NZ 127/04 SOUTH PACIFIC – Polynésie Française - Îles de la Société - Moorea Westwards, Raiatea Westwards and South-westwards and Tahiti South-eastwards - Depths.

UKHO Notice 2452/04
 NI 99/2004

LAST CORRECTION	NZ NTM No.	CHART No.
NZ 64/04	NZ 127/04	NZ 14606 (INT 606)

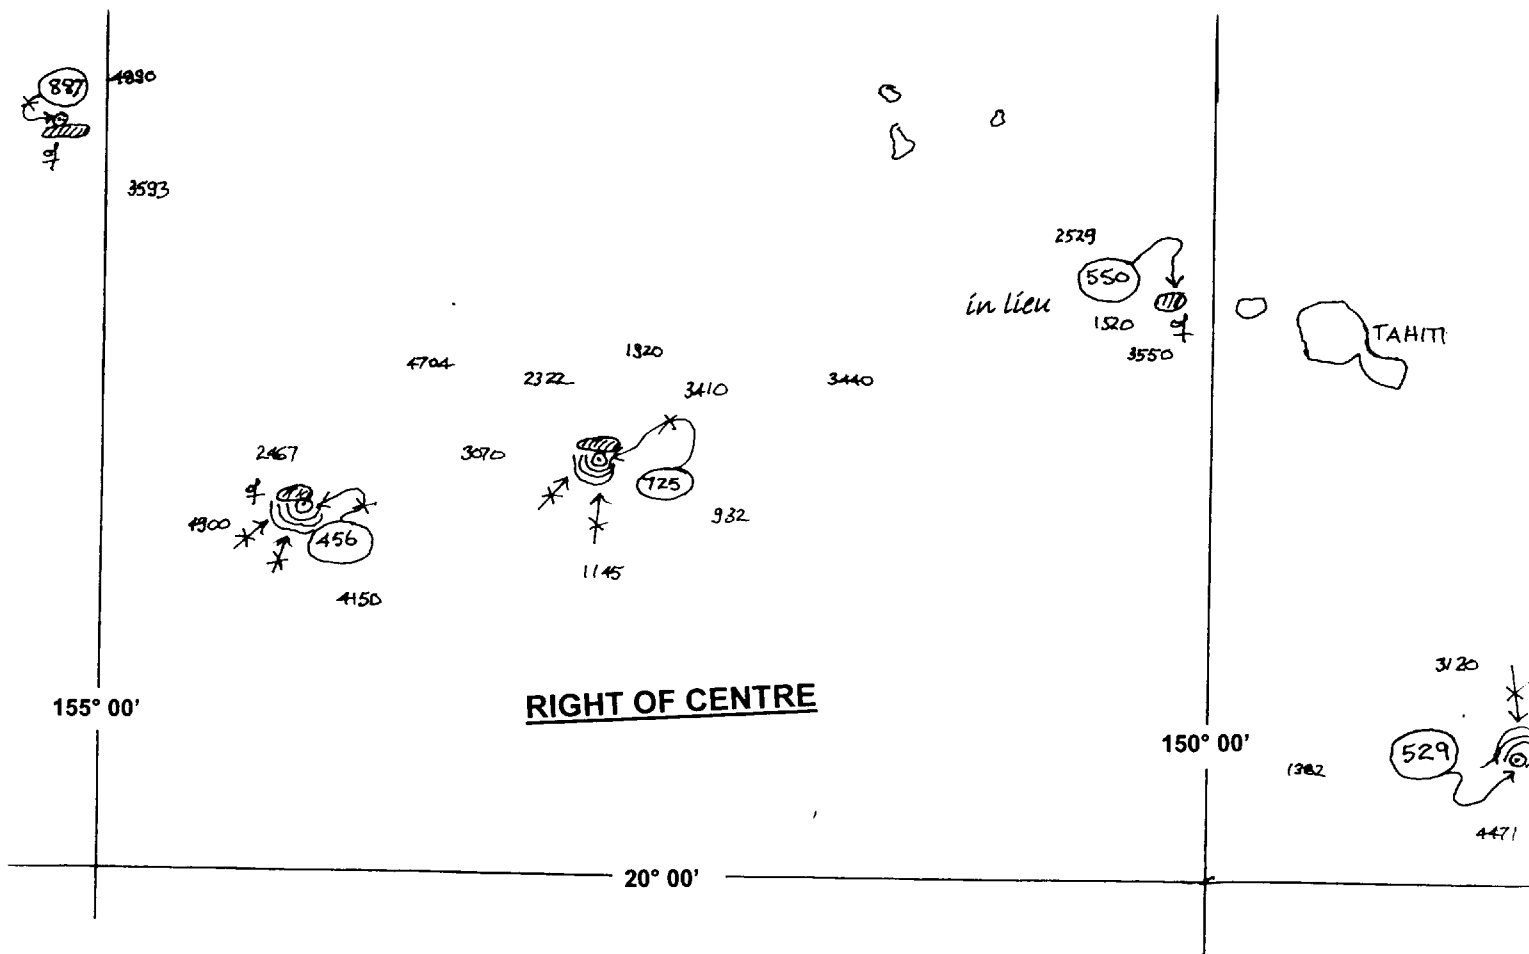
Insert	depth 887	(a) 16° 47'·0S., 155° 12'·0W
	depth 725 and extend 1000m and 2000m contours S to enclose	(b) 18° 13'·0S., 152° 46'·0W.
	depth 456 and extend 1000m and 2000m contours SE to enclose	(c) 18° 26'·0S., 154° 04'·0W.
	depth 529 and extend 1000m and 2000m contours NE to enclose	(d) 19° 28'·0S., 148° 34'·0W.
Substitute	depth 550 for depth 626	17° 29'·0S., 150° 10'·0W.
Delete	depth 1288, close S of:	(a) above
	depth 898, close N of:	(b) above
	depth 581, close NW of:	(c) above
	depth 848, close SW of:	(d) above

LAST CORRECTION	NZ NTM No.	CHART No.
NZ 64/04	NZ 127/04	NZ 14607 (INT 607)

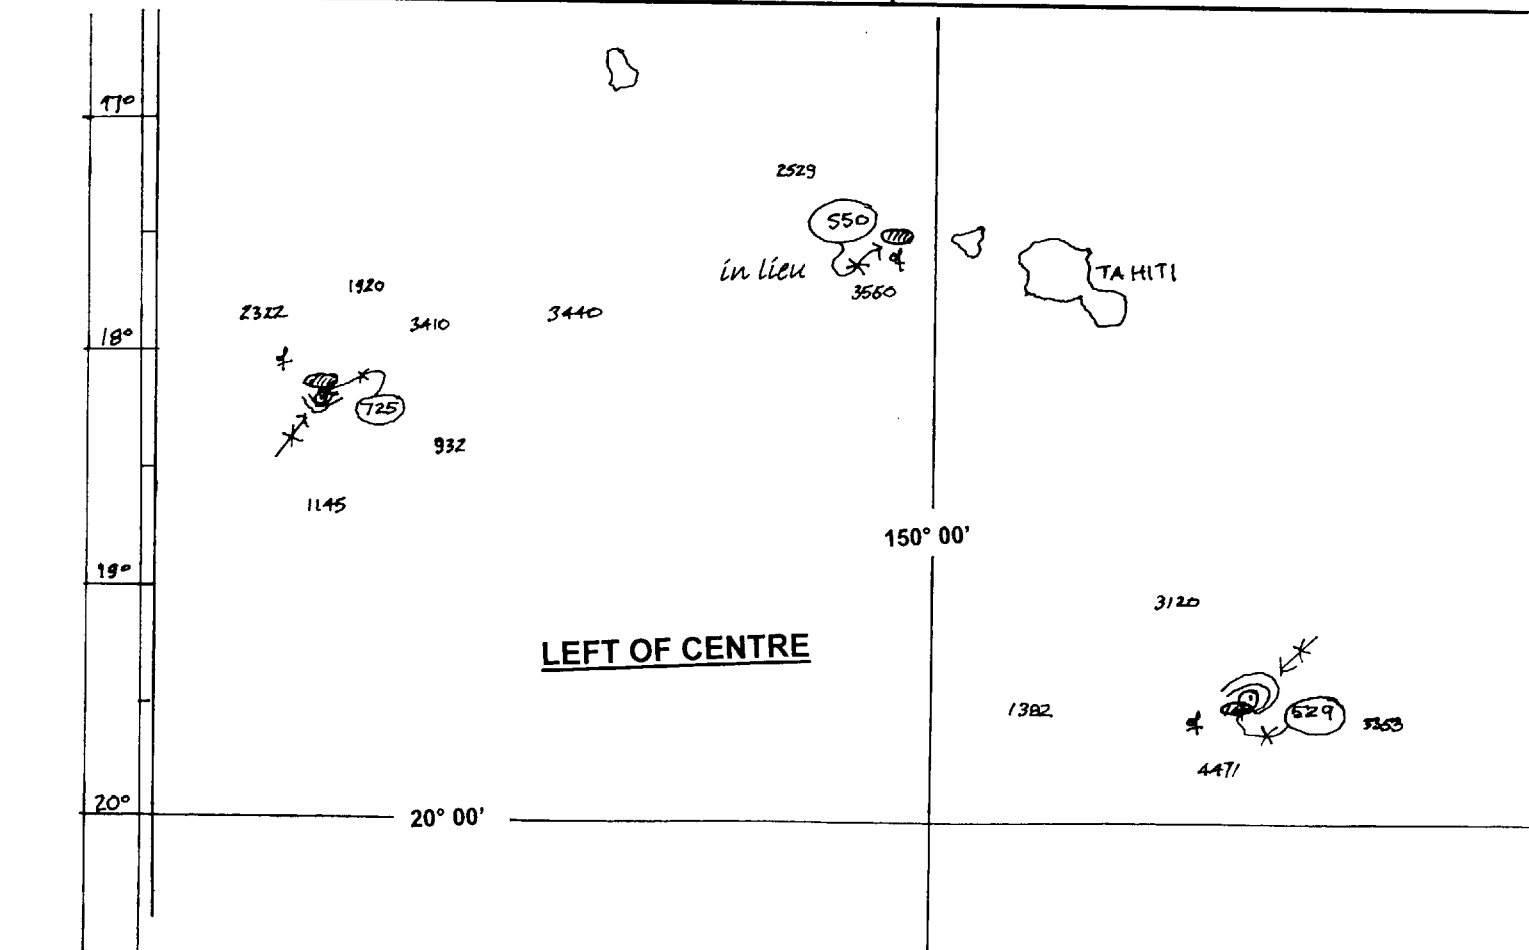
Insert	depth 725 and extend 1000m and 2000m contours SE to enclose	(a) 18° 13'·0S., 152° 46'·0W.
	depth 529 and extend 1000m and 2000m contours NE to enclose	(b) 19° 28'·0S., 148° 34'·0W
Substitute	depth 550 for depth 626	17° 29'·0S., 150° 10'·0W.
Delete	depth 898, close NE of:	(a) above
	depth 848, close SW of:	(b) above

LAST CORRECTION	NZ NTM No.	CHART No.
NZ 64/04	NZ 127/04	NZ 14061(INT 61)

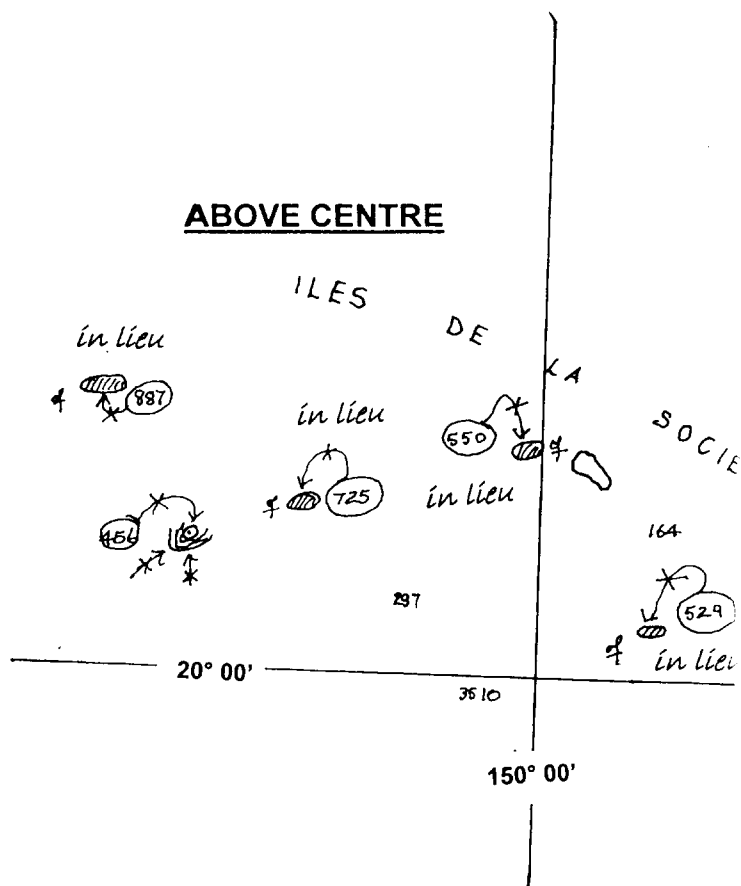
Insert	depth 456 and extend 1000m, 2000m and 3000m contours S to enclose	18° 26'·0S., 154° 04'·0W.
Substitute	depth 529 for depth 848	19° 28'·0S., 148° 34'·0W
	depth 550 for depth 626	17° 29'·0S., 150° 10'·0W.
	depth 725 for depth 898	18° 13'·0S., 152° 46'·0W.
	depth 887 for depth 1288	16° 47'·0S., 155° 12'·0W.
